**Subject:** Vickery Extension Project Response to Submissions

Thank you for your request on 3 September 2019 via the Planning Portal inviting the Biodiversity and Conservation Division (BCD) to provide advice on the Response to Submissions (RTS) report for the Vickery Extension Project.

## BCD summary of recommendations – Vickery Extension Project Response to Submissions

**Figure 1.** Areas of NA185 proposed to be added to the species polygons for the squirrel glider.

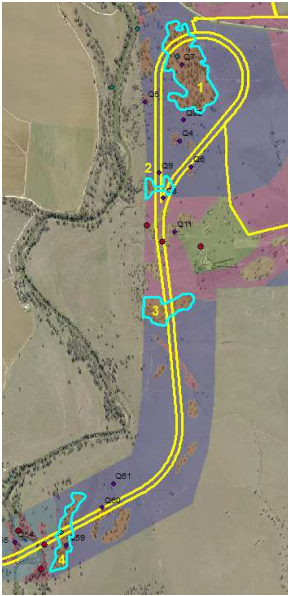
2. The four areas of NA185 that intersect with the rail spur footprint (identified in Figure 1 of this response) be added to the species polygon for the squirrel glider, and the species credits be updated accordingly.

As a result, BCD requests that the areas of NA185 highlighted in **Figure 1** that intersect with the rail spur be included in the species polygon for the squirrel glider, and the species credit requirement be updated accordingly. Specific reasons as to why these polygons have been recommended for inclusion in the species polygon are included in **Figures 2-5**.

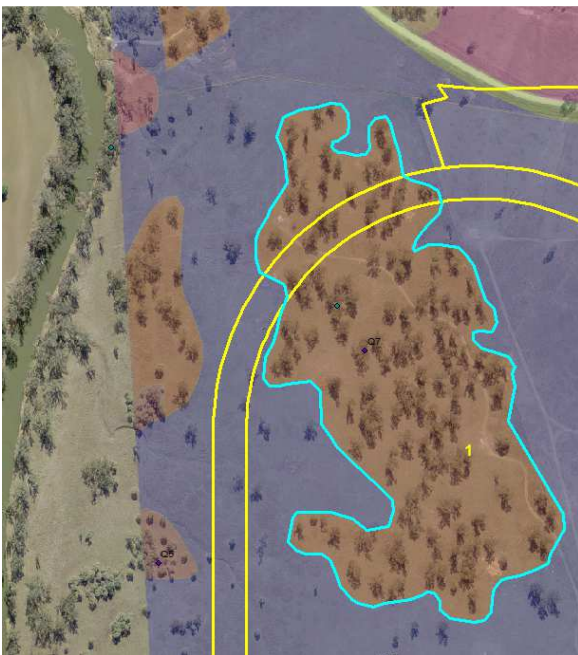
**Figure 2.** Polygon 1 in NA185.  
*Polygon 1 is approximately 150 metres from NA193 (considered to be squirrel glider habitat in the EIS); the polygon is connected to the river by trees less than 50 metres apart; quadrat 7 indicates that Pilliga box and poplar box are present with hollows also present*

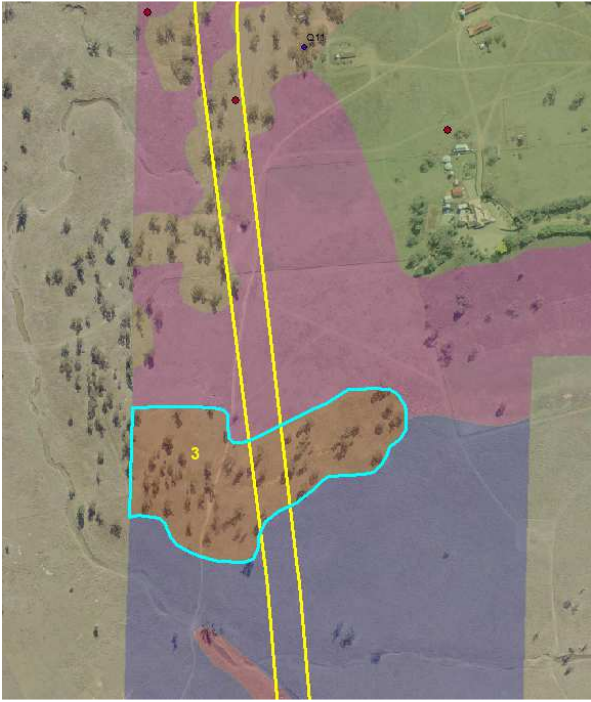
**Figure 4.** Polygon 3 in NA185. Polygon 3 is directly linked to NA324 (to the west beyond the extent of this vegetation map); the immediately adjacent NA324 polygon contains a squirrel glider record; and it is approximately 300 metres from another squirrel glider record (which was recorded in disturbed land).
